The Montreux FRANKTON RD, QUEENSTOWN

Subject: FW: RM180366 The Montreaux Ltd - incomplete application under S88

The description and supporting documentation include some inconsistencies, and some matters are insufficiently set out. Please update all plans and documentation such that they are consistent and include the necessary detail. The following are the matters I picked up on:

Subject: RM180366 - Montreux - No Stopping Solution

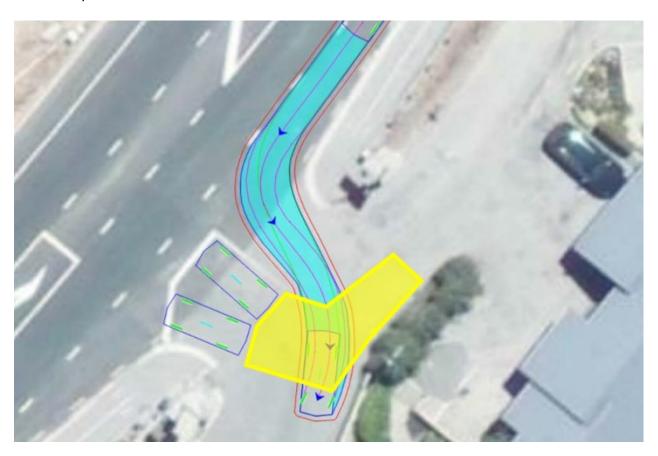
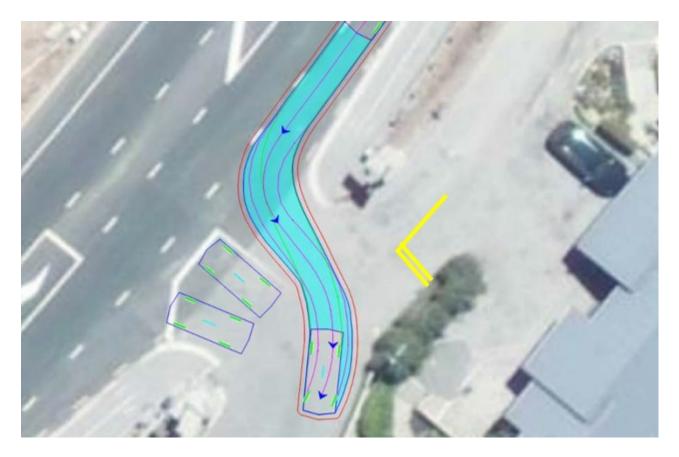
I've spoken with Andy Carr re preparing a plan of some description to show a few 'no=stopping' solutions for the intersection with the State Highway. Please see below my very rough sketch up of what I understood of this discussion image one shows a 'no stopping' painted area, image 2 shows a simple give way scenario – obviously we will need to locate this give way somewhere more appropriate so the below is simply for discussion purposes).

Before we instruct Andy to draw something a bit more to scale, Andy reminded me that we probably still need NZTA on board with any modifications to this intersection. So my question is, if we suggest a solution similar to the below to appease QLDC concerns, do we need to have this endorsed by NZTA noting that in it's current format, NZTA don't have an issue with the development?

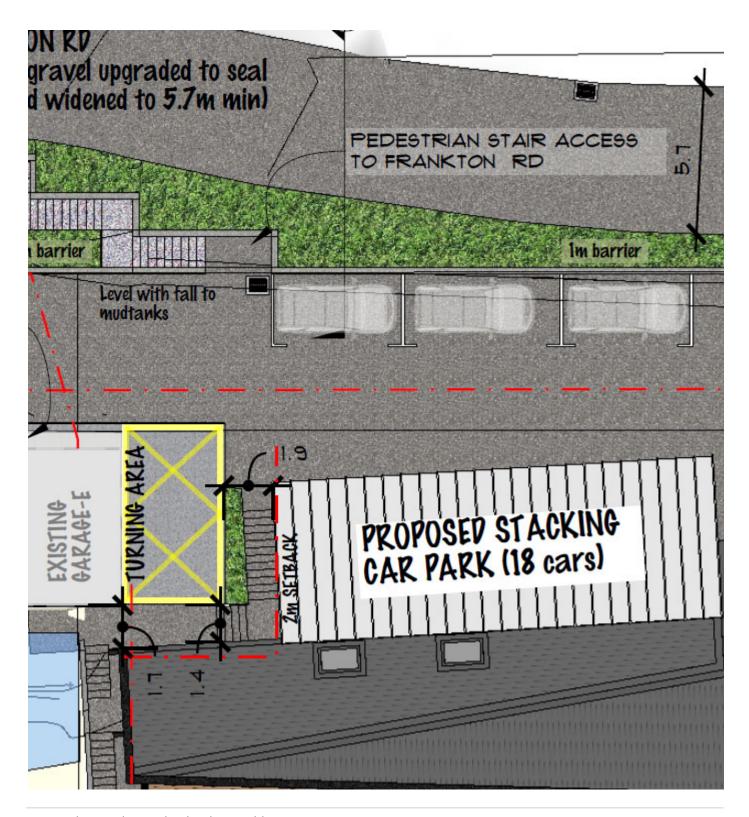
Following on from our conversation yesterday, I've confirmed with Donald that the three pick up area located adjacent to the reception. These areas were provided as temporary parking spaces associated with the car stacker and would not be provided for as extended parking. As such, these spaces will empty the majority of the time except when associated with a vehicle being removed/parked in the stacker. I've included a screenshot below.

It is proposed that a delivery vehicle would utilise this same space during onsite pickups/drop-offs (for example, laundry). As been noted previously, deliveries will be managed during off-peak periods (outside of check in/checkout times) and it is not expected that a delivery vehicle would be onsite for very long. Nonetheless, the site will be managed and any effects generated would be internalised to the site.

Delivery Vehicles

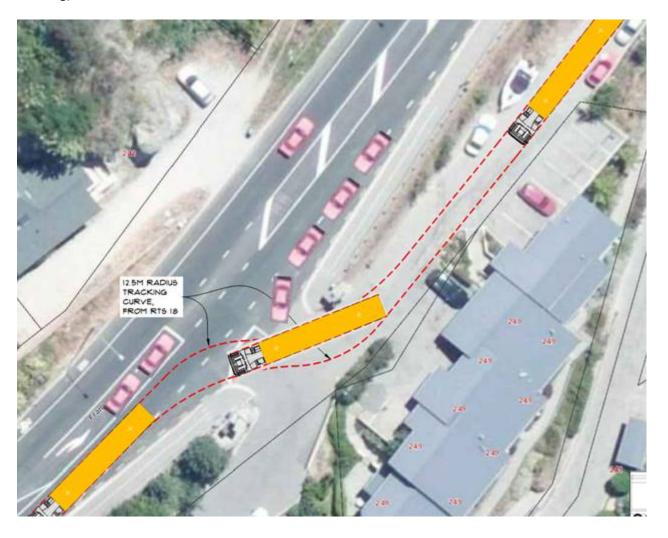
I have run tracking curves for an 8m rigid truck (small truck, ambulance, small rubbish truck – private) and can confirm that with an average 12.5m turning circle the trucks should be able to enter the site from the western SH6 access and negotiate their way to the lower vehicle courtyard via the access ramp. Once at the lower area it is assumed that vehicles will use a temporary loading/unloading area (the three temporary set-down parks??) without blocking access to the private dwellings to the west. Once loading/unloading has occurred the trucks will use the dedicated 3.8m wide turnaround area to exist the site in a forward direction. The use of the western SH6 access will be encouraged through the design of the access (sealed to west and gravel to east – plus signs and kerbs) and the management for the site will actively encourage access from the west only.

The previous comments have suggested that parks P19 & 20 would be used for temporary loading/unloading of vehicles. This approach is not deemed acceptable as these parks are required for permanent over night parking of guests. Can you please confirm that these parks will not be used for loading/unloading and where this provision will occur (as above I would assume on the three set-down parks against the northern boundary??). Once we have a suitable temp loading/unloading area then I will likely be in a position to accept that suitable vehicle delivery provisions will exist for the development.
